ADDENDUM NO. 02

TO: PLANS AND SPECIFICATIONS FOR STATE OF MISSOURI

Renovate Interior & Exterior
Anderson Readiness Center
Anderson, Missouri
PROJECT NO.: T2421-01

SHEET TITLE:
**DEMOLITION
PLAN**

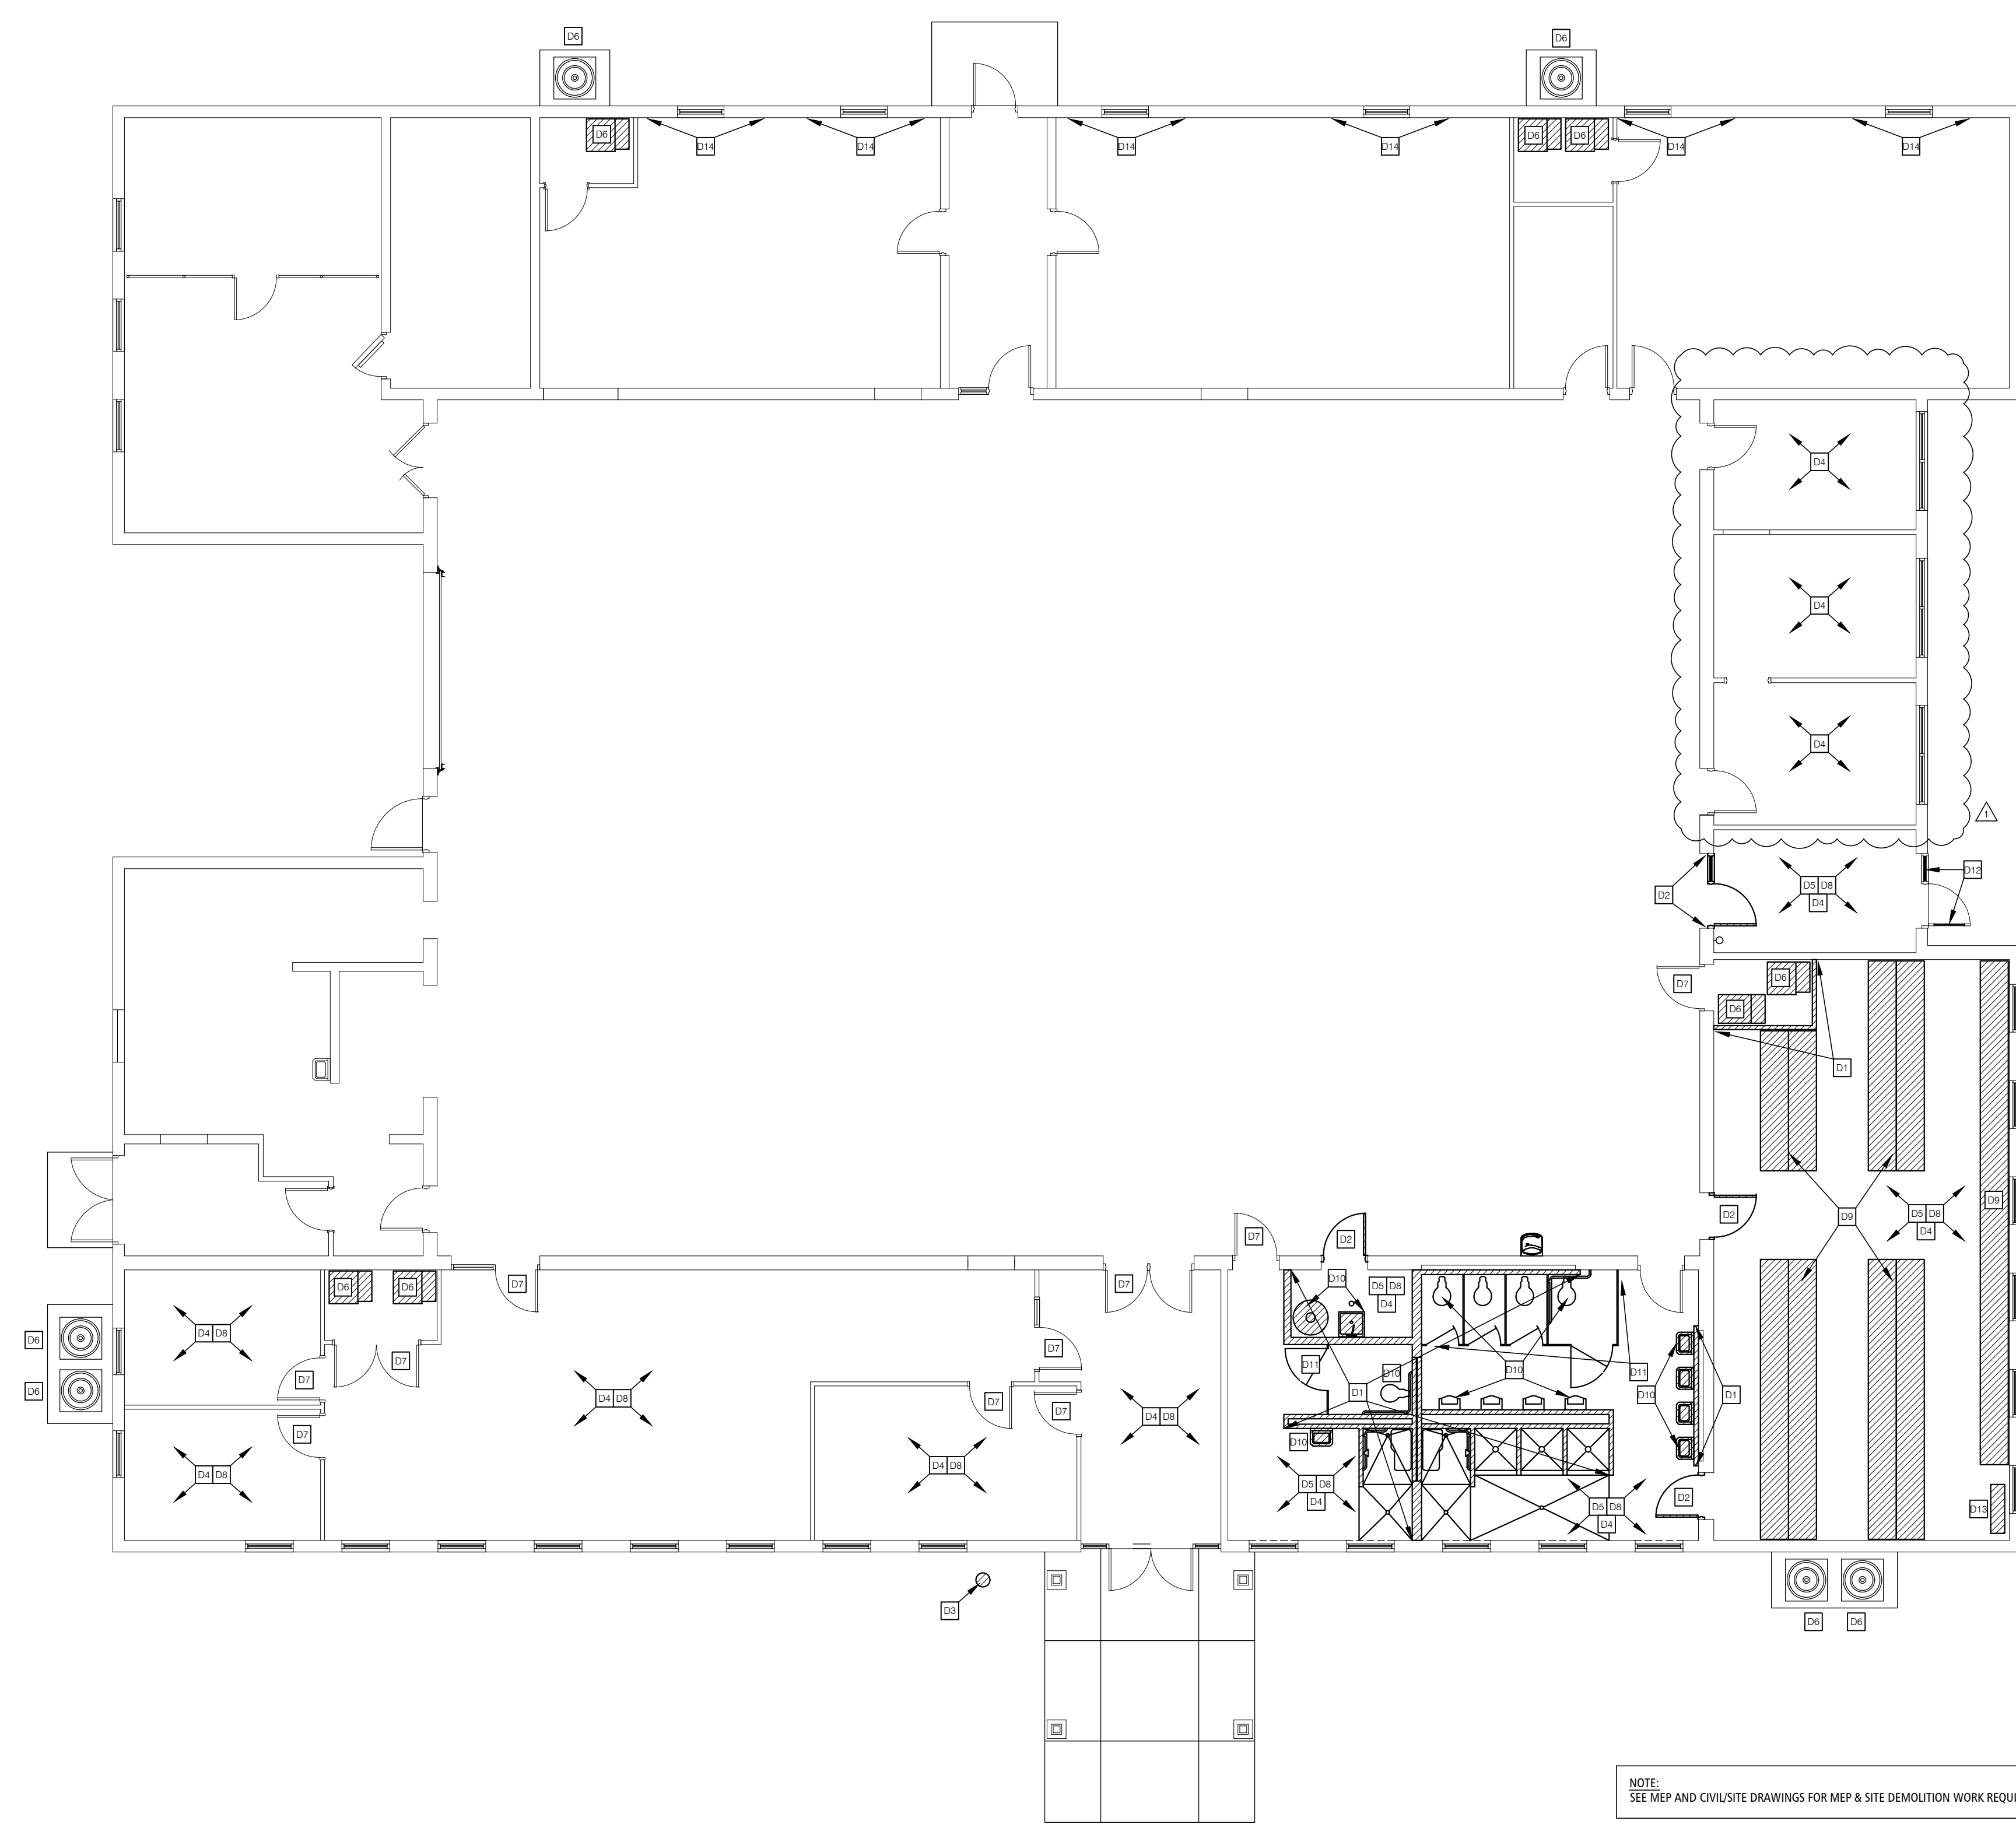
1. Sheet A-010 – See Attached revised sheet A-010
 - a. Added keynote D4 to offices 119, 120, and 121.

SHEET TITLE:
DOORS

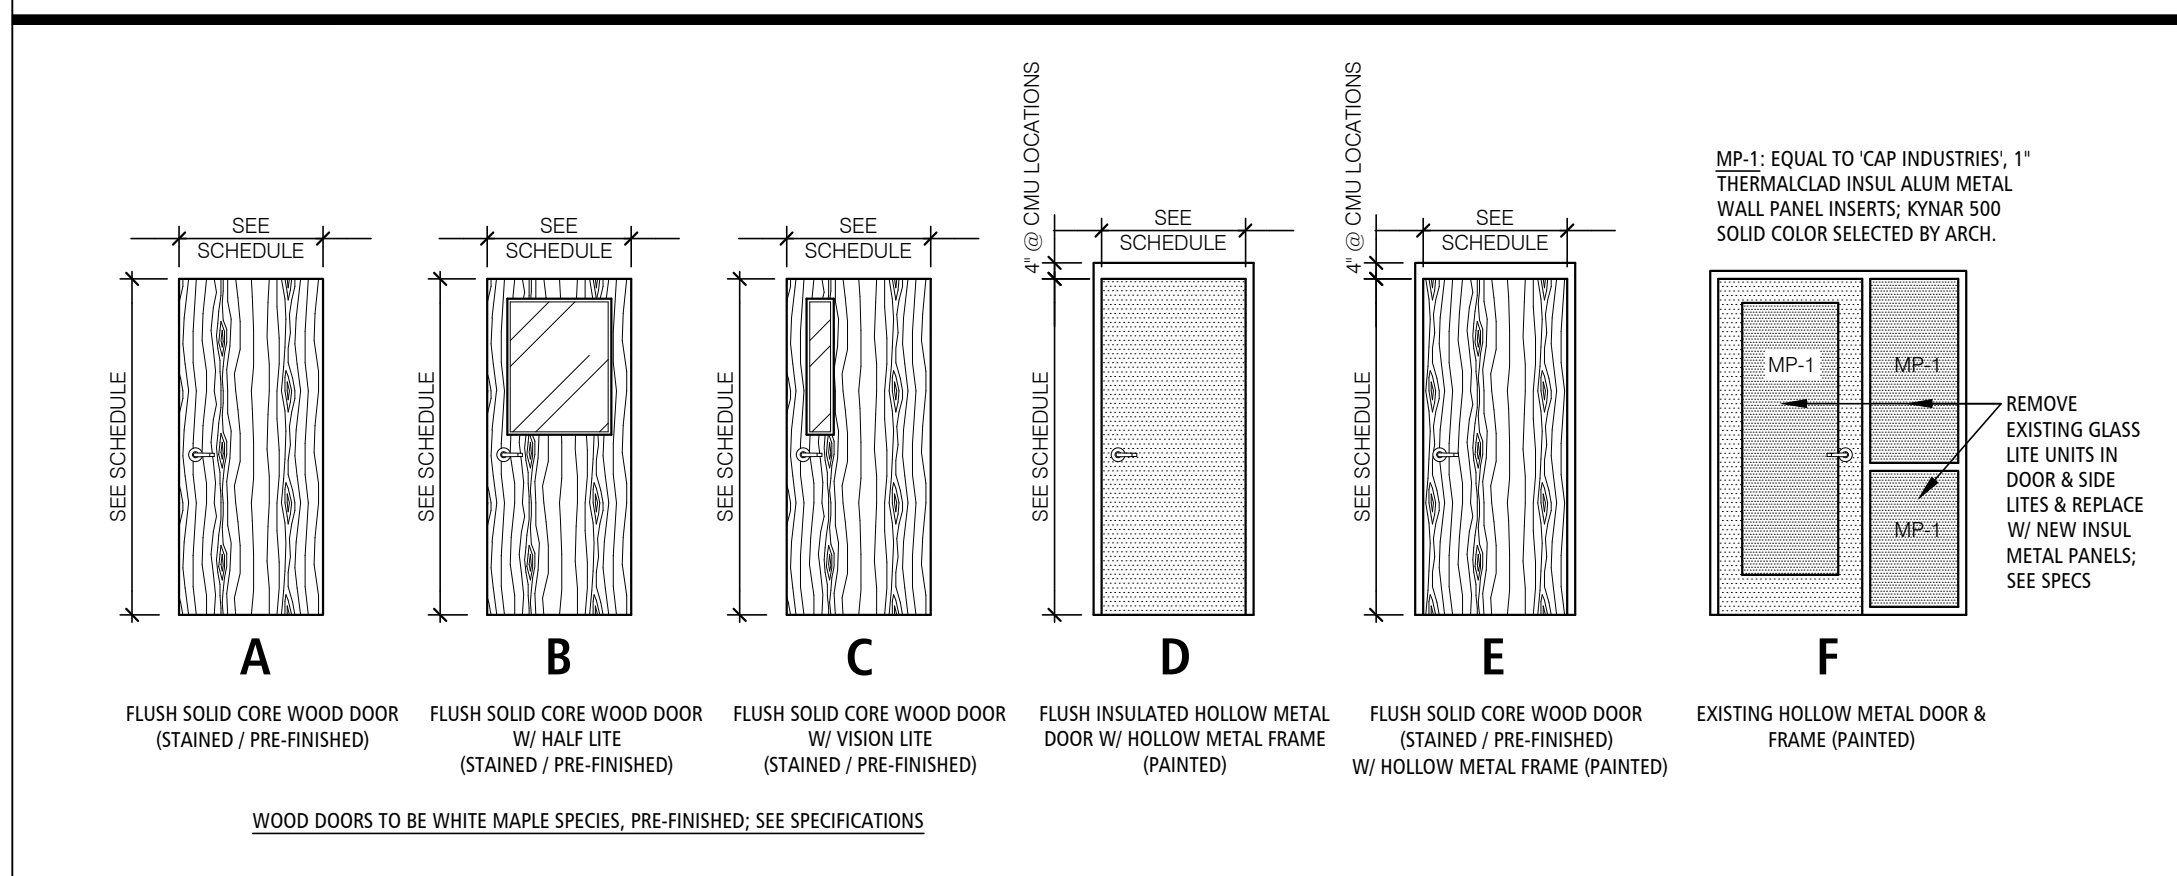
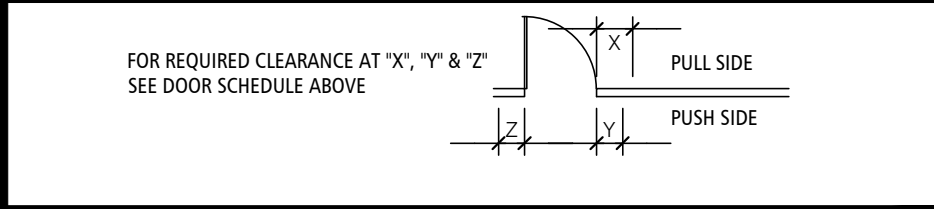
2. Sheet A-300 – See Attached revised sheet A-300
 - a. Updated door hardware to clarify that doors 123, 124, 126, and 127 are wood doors, not HM Doors.
